RE: Coliban Water Water RFI 27 MARCH 2013

Further to recent discussions I have outlined in this letter and its attachments the further information requested by Coliban Water on 5 April 2013 regarding the applications to build 3 broiler farms at Baringhup West.

RE: EPA RFI 10 APRIL 2013

RE: Goulburn – Murray Water RFI 27 MARCH 2013

ATTACHMENT 1: 2/3 FARM FOOTPRINTS

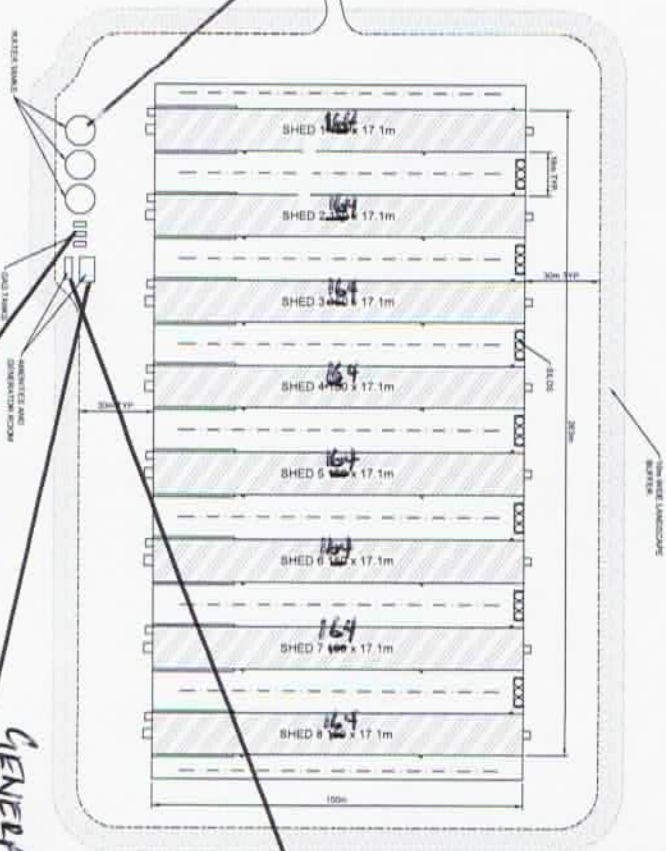
As shown on the site plans included in Attachment 1, there is a waterway known as Boundary Gully on the west side of the property. Farms 1 & 3 are nearest to this waterway. The distance of the buildings of Farms 1 & 3 are well over the required distances by the planning codes. Water runoff from the farms is only rain water from the roofs of the sheds and catchment on surrounding land and roads. The drainage plans of each farm will ensure that all runoff water is captured by drains and deposited into the proposed settling ponds. Each farm will contain a settling pond of approximately 10ML as shown in the site plan at Attachment 1. The land is not known to be subject to flooding.

Attachment 1

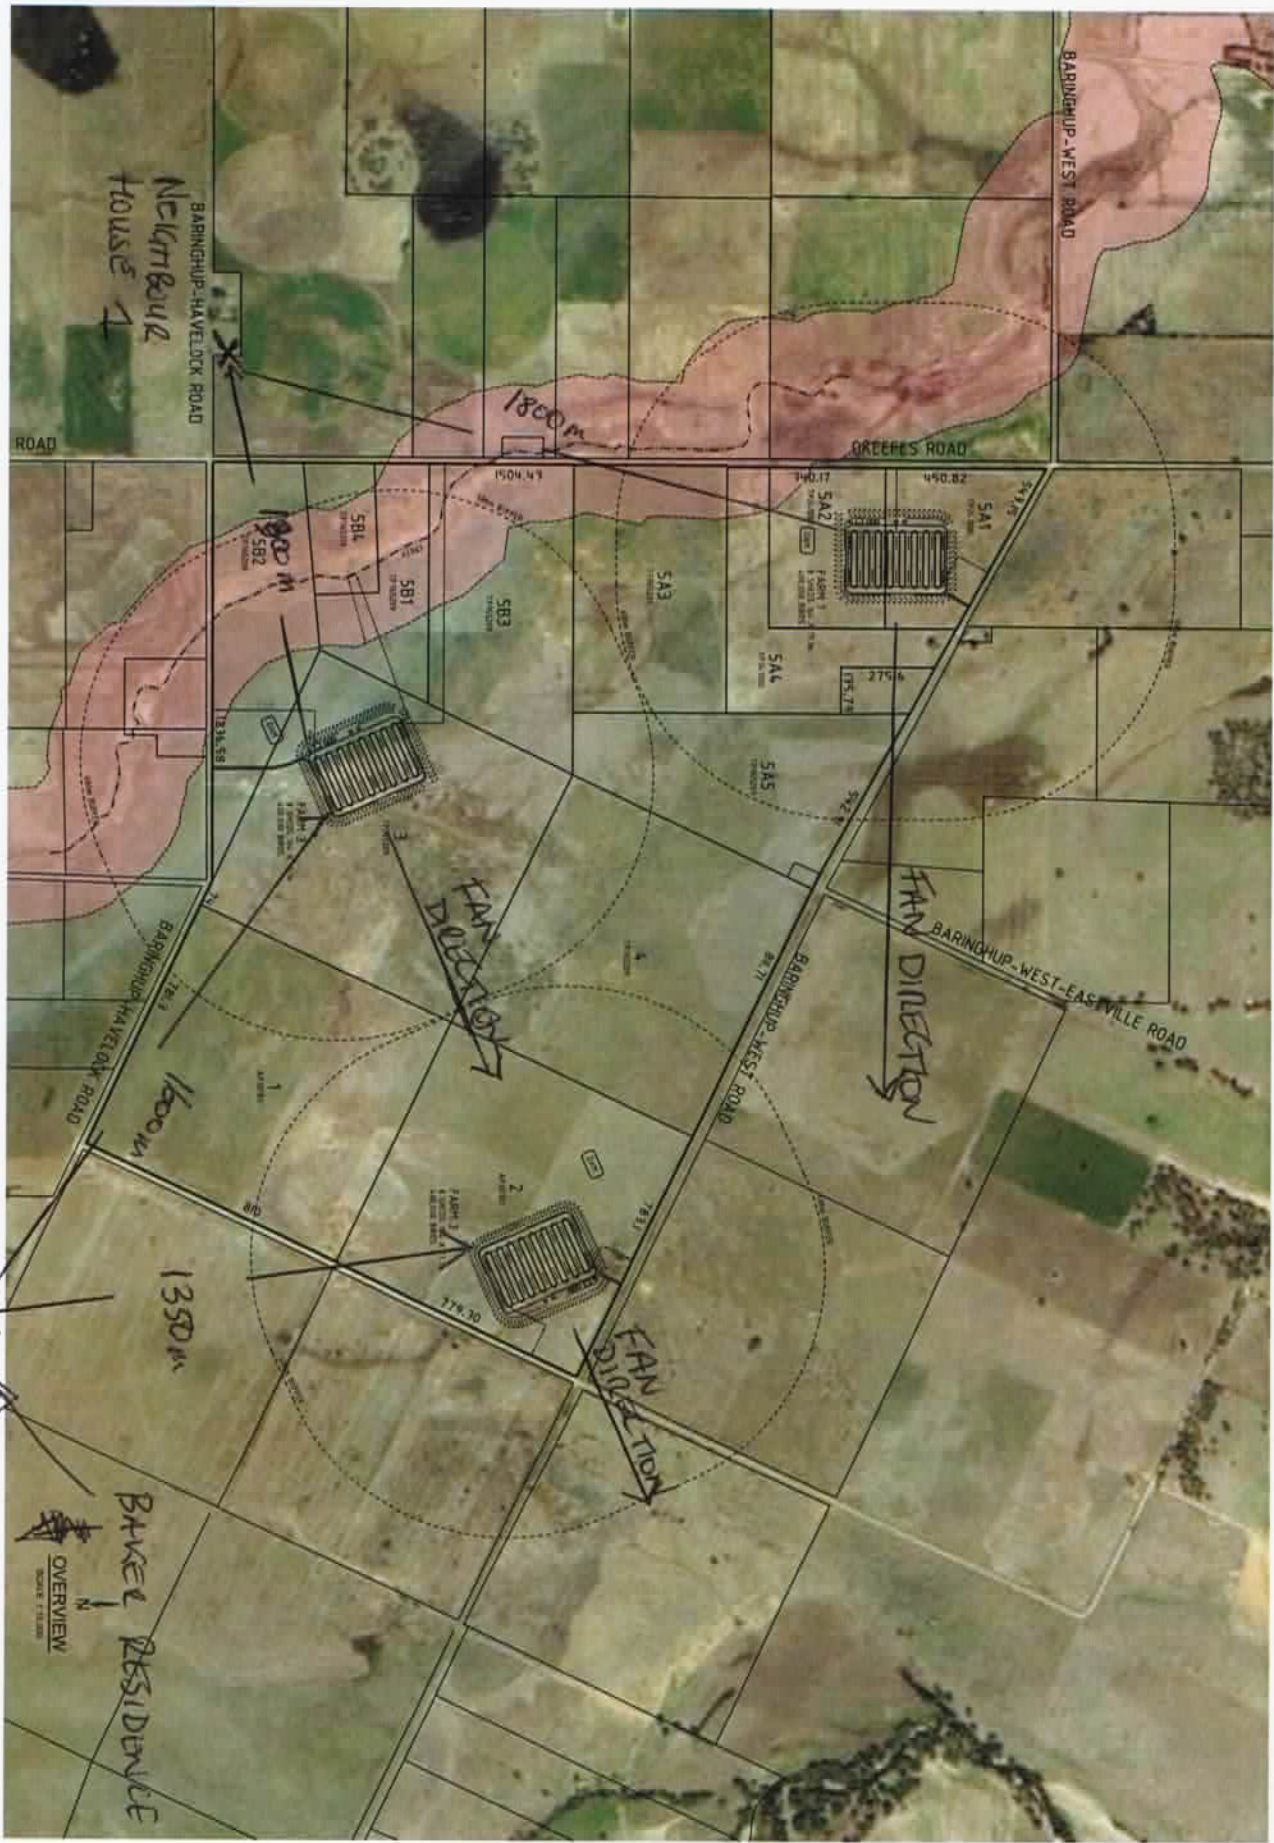
RFI 1: A detailed map with the surrounding residences and distances from each proposed farm. Details of any other broiler farms in the area and the distances to them.

RFI 2: The direction of the fans

A house on the South West side of the farms is approx. 1,800 metres from Farm 1; approx. 3,100 metres from Farm 2; and approx. 1,300 metres from Farm 3 (refer Attachment 1).

A house on the South East side of the farms (Baker Residence) is approx. 2,600 metres from Farm 1; approx. 1,300 metres from Farm 2; and approx. 1,600 metres from Farm 3 (refer Attachment 1).

Response to RFI 2:As shown in Attachment 1, the air direction of the fans are as follows:

- Farm 1 – East
- Farm 2 - North East
- Farm 3 - North East

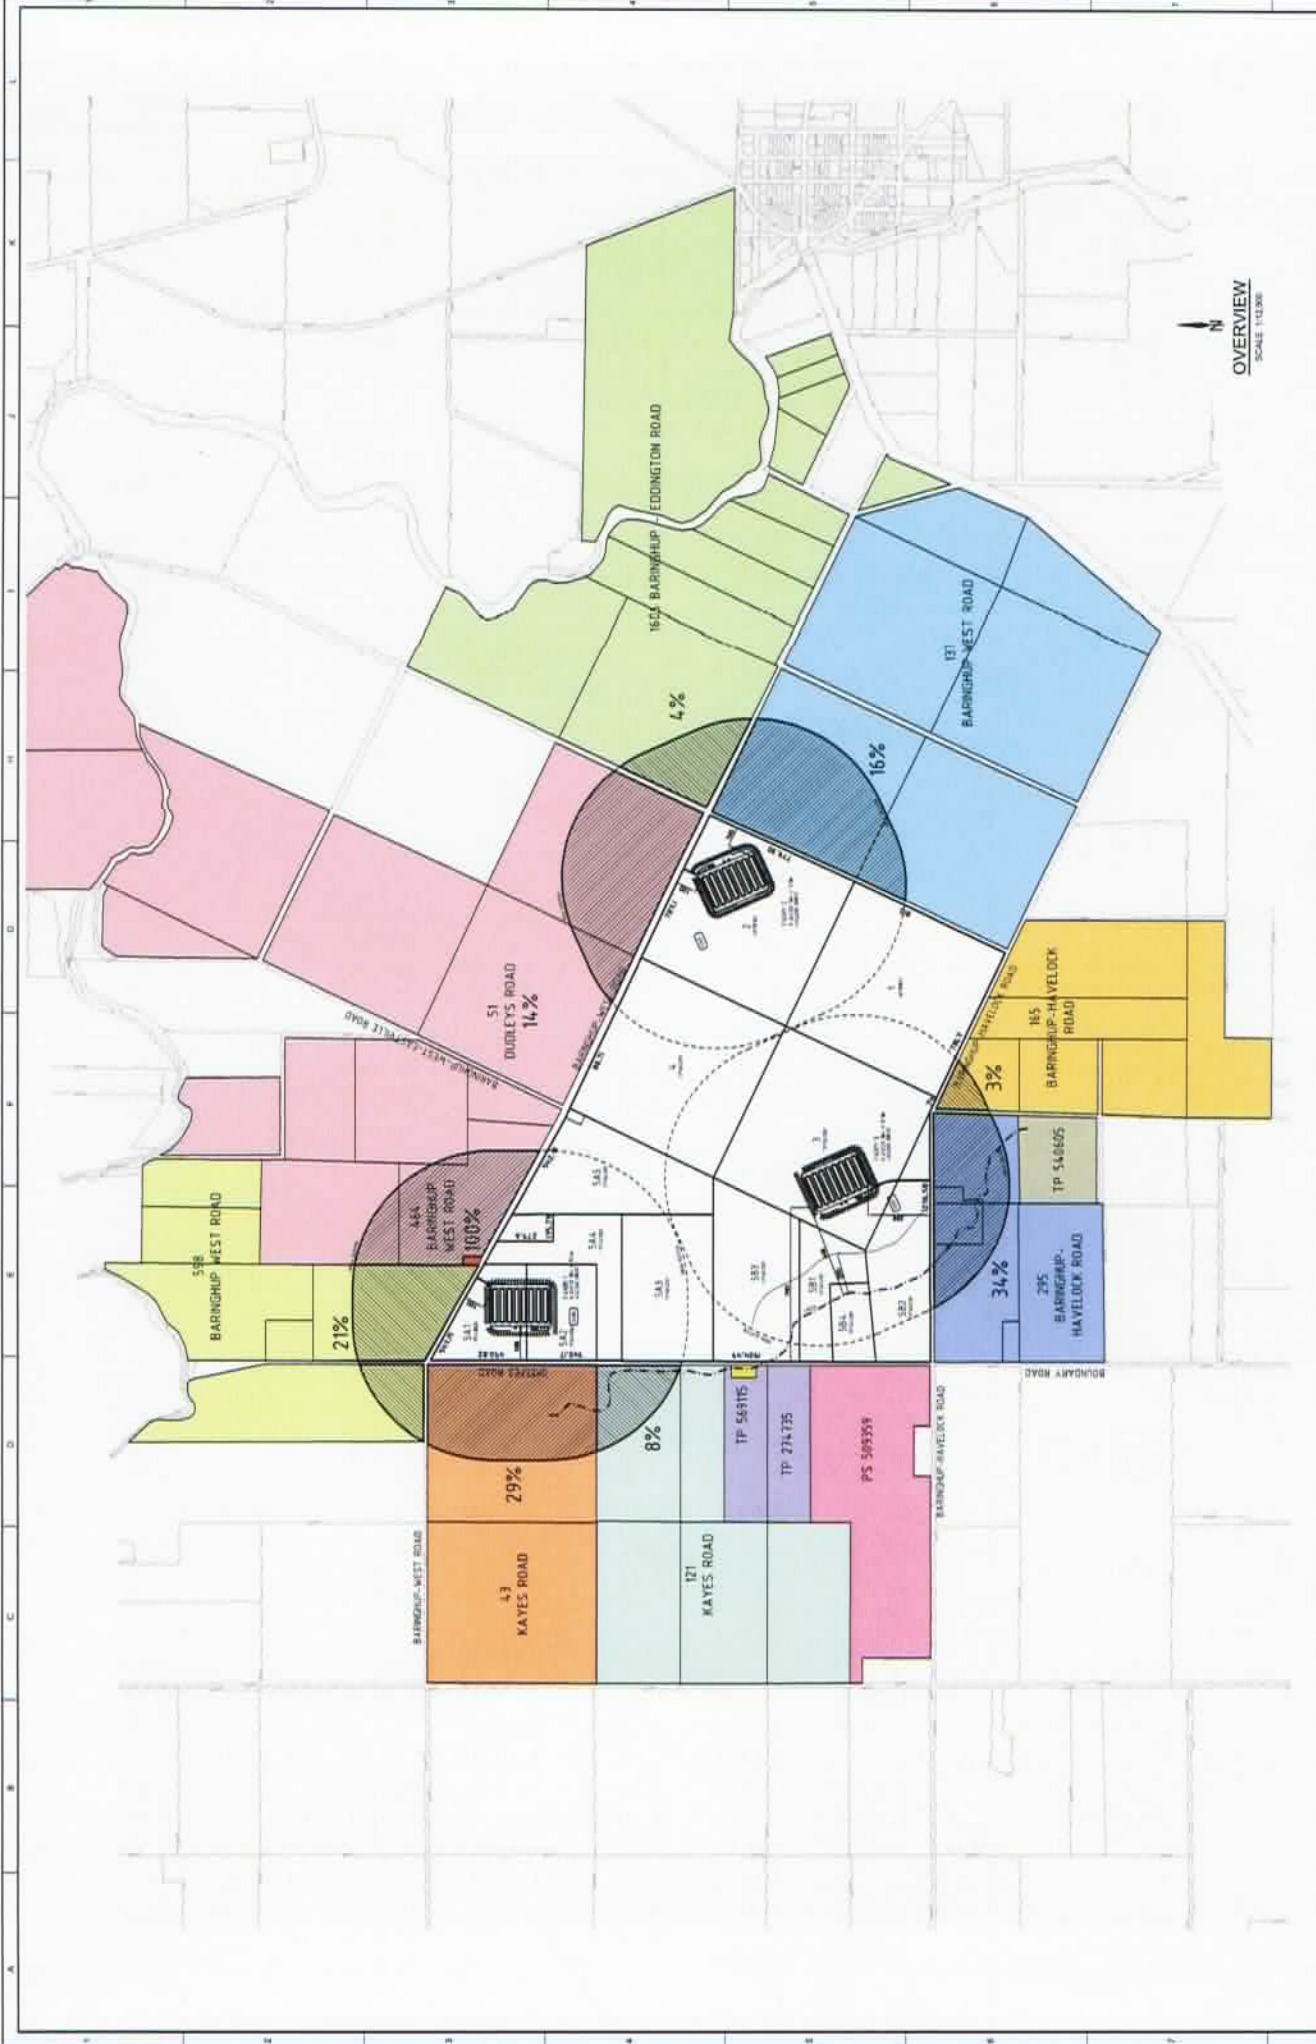
RFI 1: A scale drawn site plan showing dimensions and the location of all existing and proposed features of the development including sheds, managers residence, dam, litter stockpile, amenities buildings, etc. The site plan must identify the setback distances to any waterways, low lying areas or significant topographic features.

RFI 2: Proposed measures to protect waterways from the effect of development and whether any areas of the land are subject to flooding.

Response to RFI 1: See attached site plans at Attachment 1. Note that there will be no litter stockpiles and the application does not include an application for managers residences.

Response to RFI 2: As shown on the site plans included in Attachment 1, there is a waterway known as Boundary Gully on the west side of the property. Farms 1 & 3 are nearest to this waterway. The distance of the buildings of Farms 1 & 3 are well over the required distances by the planning codes. Water runoff from the farms is only rain water from the roofs of the sheds and catchment on surrounding land and roads. The drainage plans of each farm will ensure that all runoff water is captured by drains and deposited into the proposed settling ponds. Each farm will contain a dam of approximately 20ML as shown in the site plan at Attachment 1. The land is not known to be subject to flooding.
